Re: Amendment to Ground Control Plan; Wellington, Utah Preparation Site
MSHA ID No. 42-00099

**Ground Control Plan
(Working Document for Phase One of Operations)**

AMENDMENT 1**9/19/97****Drainage and Diversions**

FIG. 2
IMPOUNDMENTS

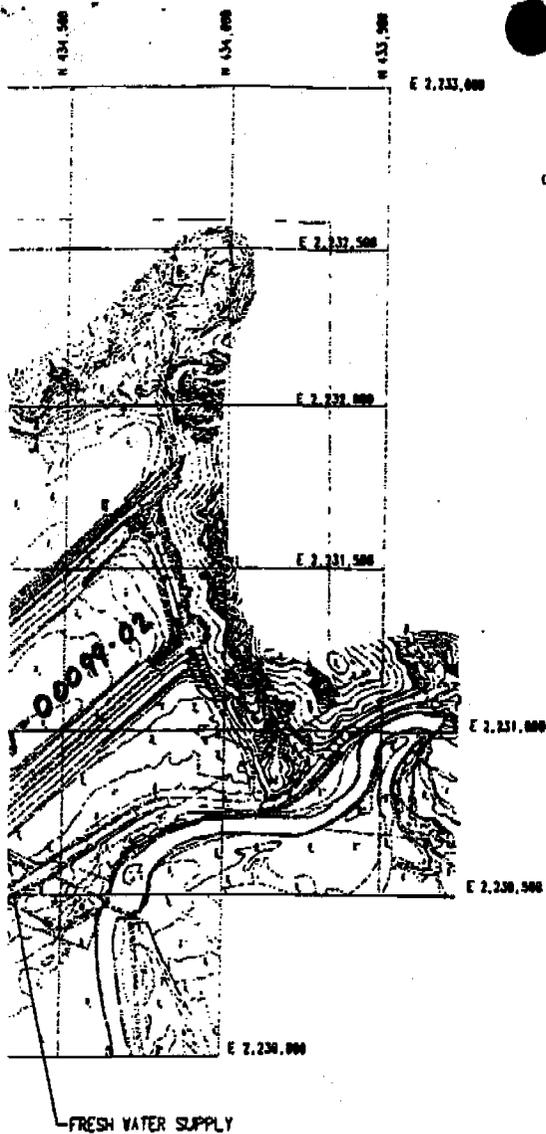
The Wellington site has three existing impoundments dikes, 1) upper, 2) lower, and 3) clearwater. (See Figure 2 -Impoundments: Ponds and Pipelines Site Plan). Corresponding impoundment numbers are included on the aforementioned attachment.

The impoundment, described as the Refuse Basin, impounds drainage from Water Shed #7 and process water. Flow from some undisturbed areas is diverted around the Refuse Basin areas. These diversions are discussed below.

- The so-called Permanent Diversion is a Permanent Diversion that diverts runoff from 680 acres of undisturbed hills to the east of the Refuse Basin area. The Permanent Diversion was constructed approximately 10 years ago. The ditch was originally designed to have a 10-foot wide bottom width with 1.5 horizontal to 1 vertical side slopes and a 4 inch thick layer of riprap in selected locations (see Dwg. E9-3427). Field examination (June 19 1993) and analysis of the 1991 mapping reveals that the channel is well-vegetated and is stable. This diversion is designed to safely pass the runoff produced for 1 100-year, 6-hour precipitation event since it prevents run-on into the Upper Refuse Basin.

- The Siaperas Ditch is an old ditch that collected runoff from agricultural and undisturbed lands northwest of the basin area. The tributary area includes as much as 1266 acres in addition to the flow from the 680-acres drainage area diverted by the Permanent Division that empties into the Siaperas Ditch, for a total tributary area of 1946 acres. The Siaperas Ditch is designed to safely pass the runoff produced from a 100-year, 6-hour precipitation event since it prevents run-on into the Upper Refuse Basin.

- Drainage within the Refuse Basin are also designed with a single spillway and an emergency spillways that in combination will safety pass runoff from a 100-year, 6-hour precipitation event.

- Under Covol's operations, all of the runoff will be contained within the Refuse Basin sediment pond, which has contained and will continue to contain, all runoff from Watershed #7; the Refuse Basins will continue to meet regulator requirements for storage and spillway capacities.
